Detailed Concerns

Comments - Calvary Worship Center Development Plan Submitted 06-03-2014
 CPC PAD 14-00004
 The undersigned support the above comments unless noted otherwise.

5 Major Concerns/Requests

Concern 1 - Character of "Cribblock" Retaining Wall

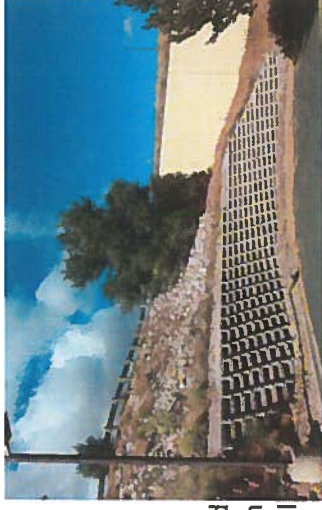
Behind vacant 7-11
on Manitou Avenue

To the side and
behind Woodman
and Windchime Pl

Behind Sam's Club at Academy and Woodman.
Maximum Height of 16'

Only three local examples of
Cribblock walls.

Concern 1 - Character of Retaining Wall Without Setback

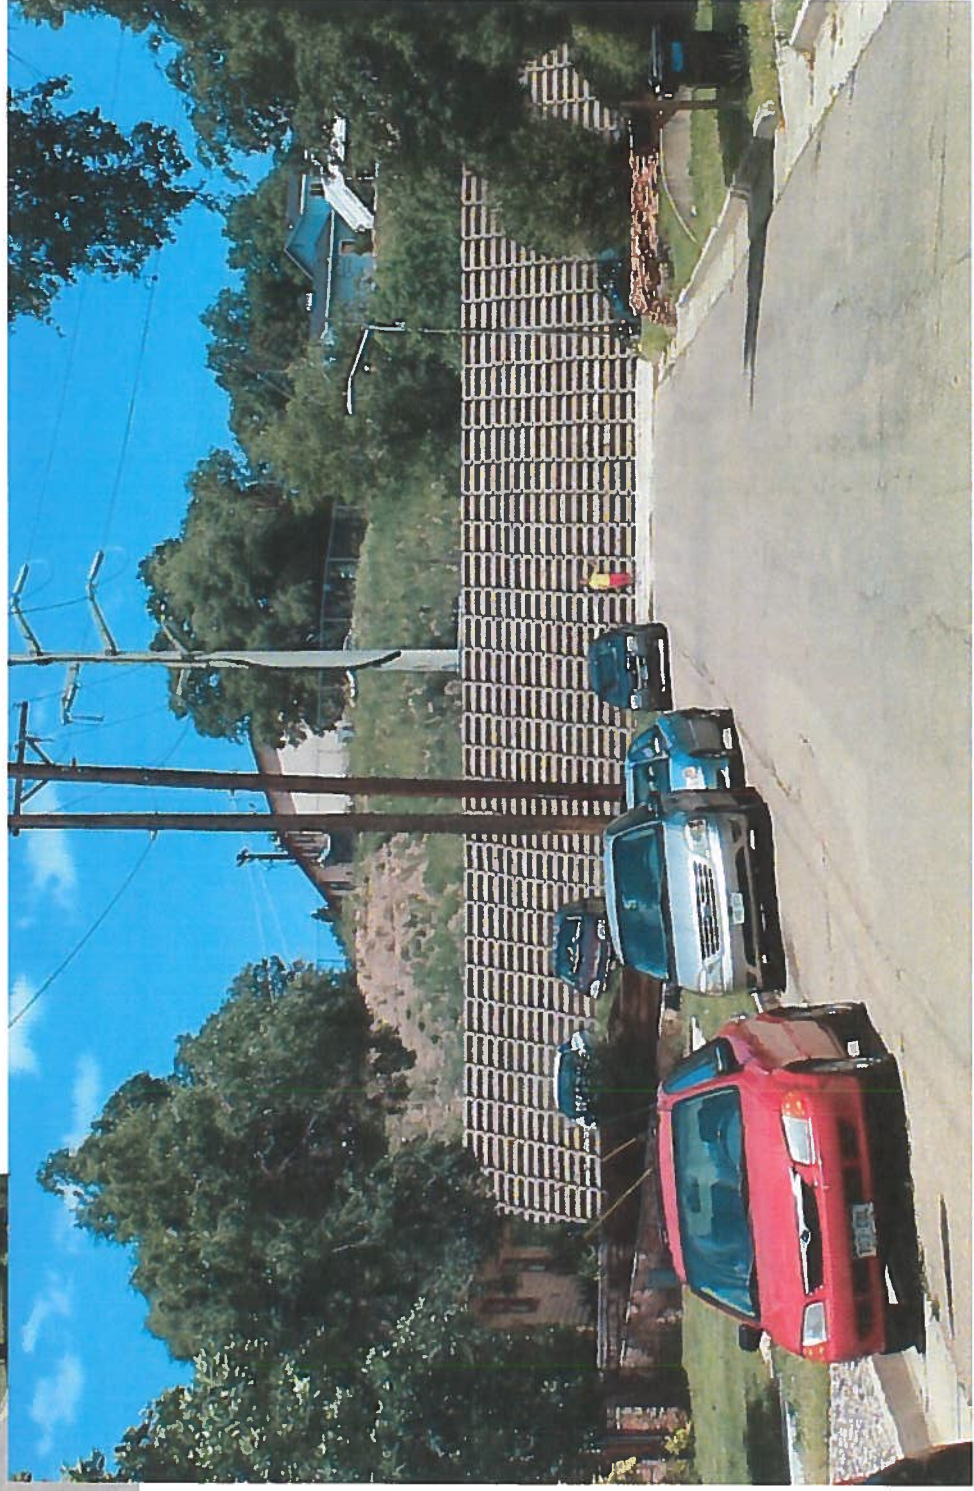
Photo simulation of 16' Criblock wall at the end of 28th street. Creating a "Wall" as bad or worse than the 2006 proposed development that was disapproved. **The "Accessory Structure" is only inches from the property line and, if in an R-2, it would need to be set back 25'.**

Well know civil engineer in Colorado Springs texted to me, "Not used to much around here as they are typically reserved for areas where you want to landscape the wall itself. As nothing grows here without irrigation, and walls don't like water in their subsurface they don't get used."

Concern 1 - Better Gravity Systems than "Criblock" wall

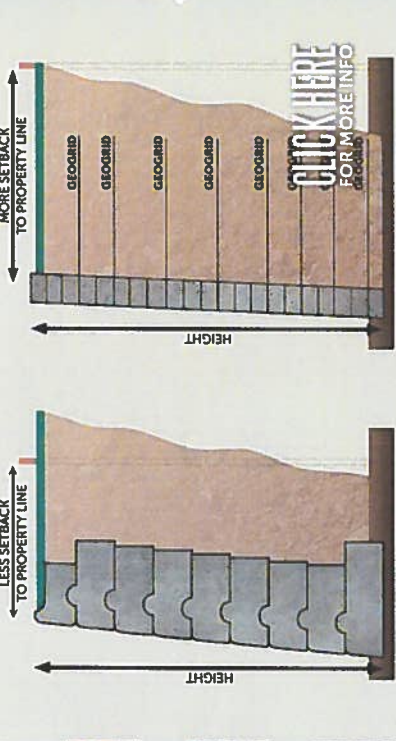
There are other gravity retaining wall systems that have been made to look more residential in scale and have shown to be more durable in our climate.

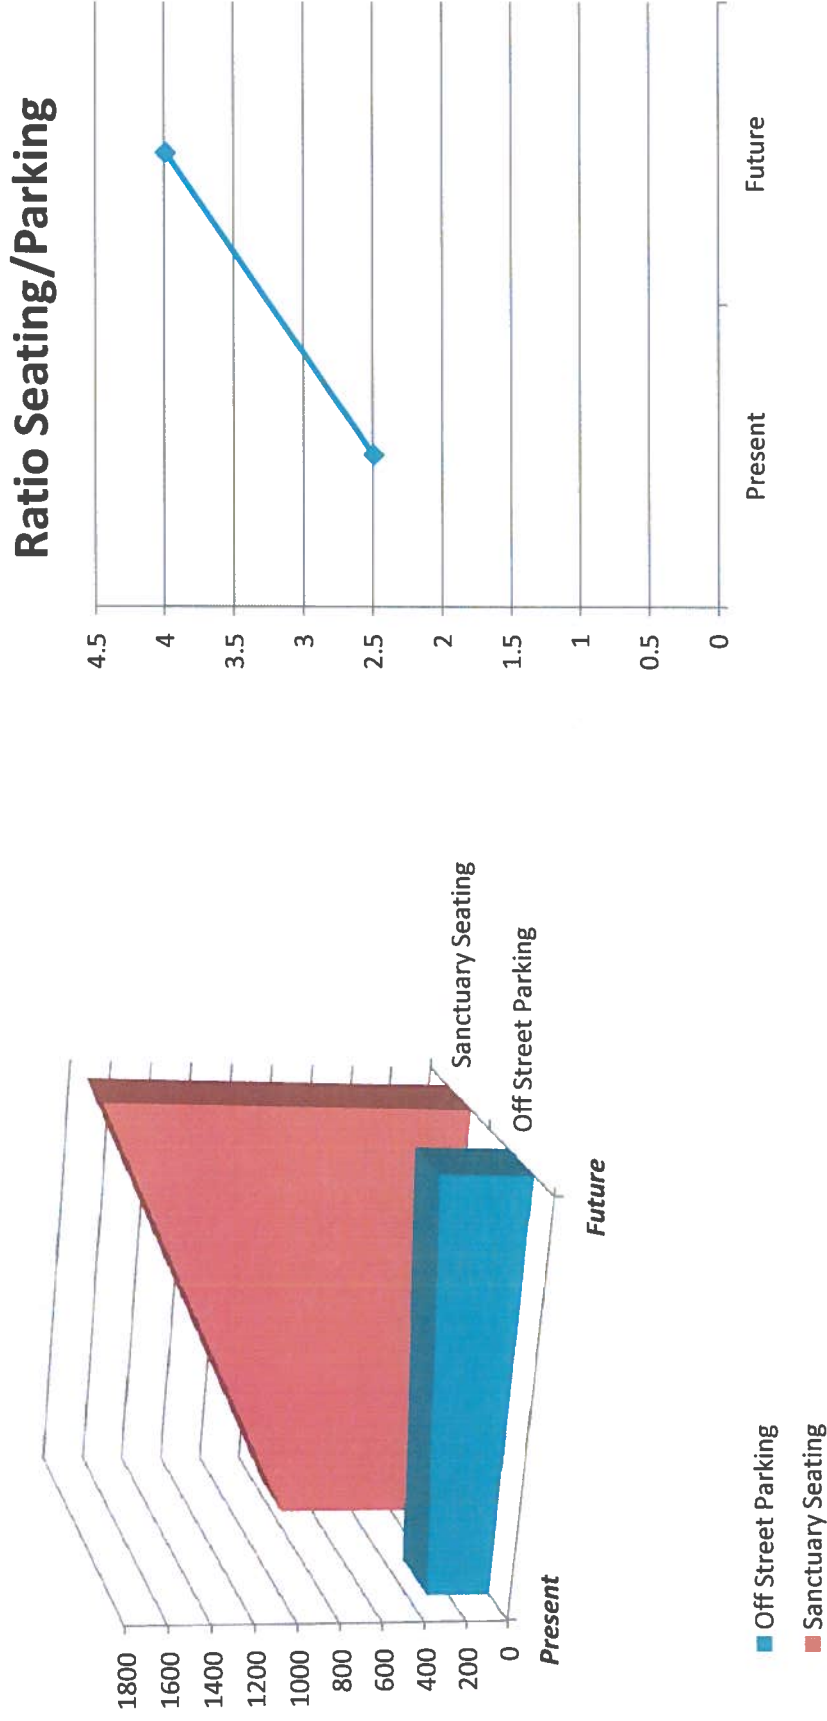
On July 13th at 11 AM there were 90 cars parked on the streets. On October 12th at 11 AM, the number of cars parked on the street and in non-designated parking spaces (and subtracting any vacant parking lot spaces) were 102. Let's assume on an average Sunday there can be up to 98 cars that **need** to park on the street. Now lets extrapolate what the expected off street parking will be after the expansion.

Current Parking Data
 Sanctuary Seating 753
 Parking 302
 Estimated street parking 98* **This number is very low based on the last two studies!**

Proposed Parking Data
 Sanctuary Seating 1780
 Parking 446

Extrapolated Street Parking 500+

Concern 2 – Street Parking and Traffic

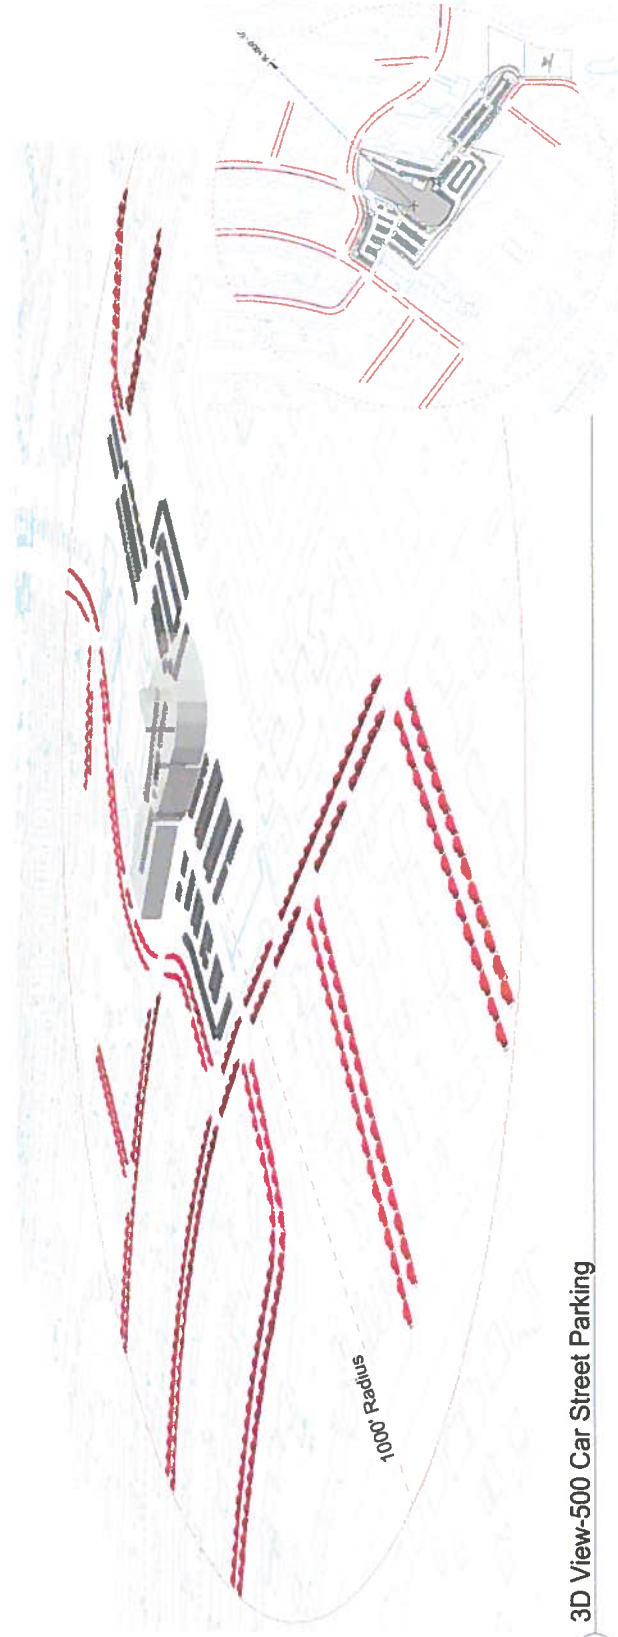
The reason the expansion will generate in excess of 500 cars looking for a parking space on the streets is very easy to see by these graphs that show:

1. Sanctuary seating will increase by 236% but Off Street Parking will only increase by 48%.
2. The ratio of seating to off street parking spaces will increase from about 2.5 to 4.

Starting with traffic congestion and adding geometrically more seating and less parking just does not work!

1 3D View-500 Car Street Parking

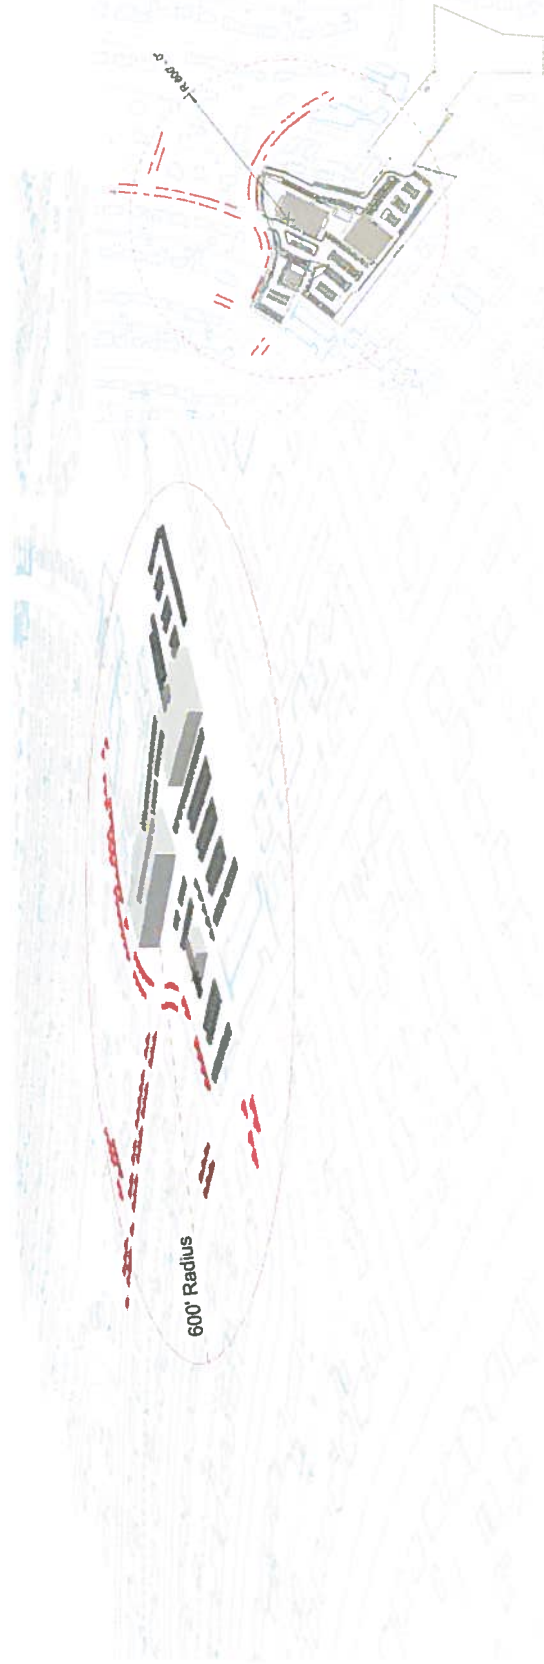
Concern 2 – Street Parking 3D View

Concern 3 – Lighting

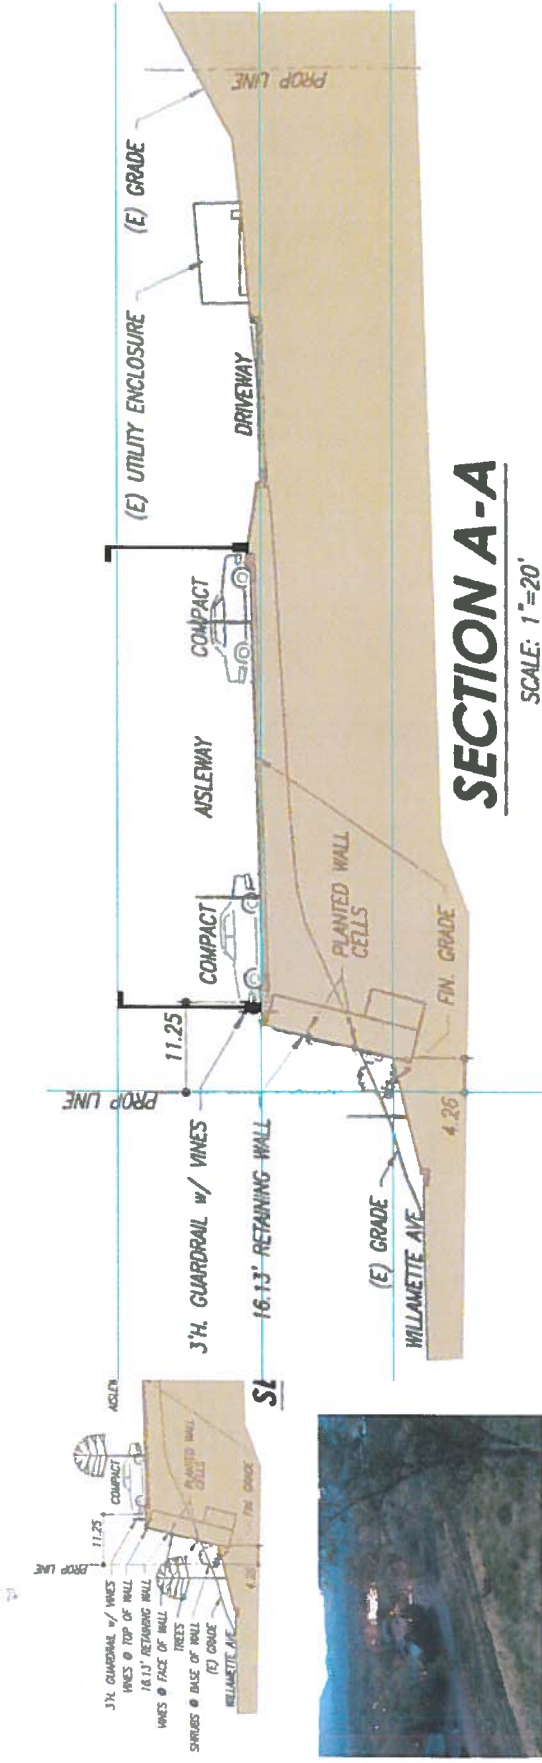
The photometric plan for the development plan has not been completed. Pole lighting 18' above the parking lot that is 16' above the neighborhood below is not residential in lighting design. The lighting should be pedestrian to minimize spill over into the neighbors below. The photometric plan should be completed and reviewed by city and neighbors before the DP is approved.
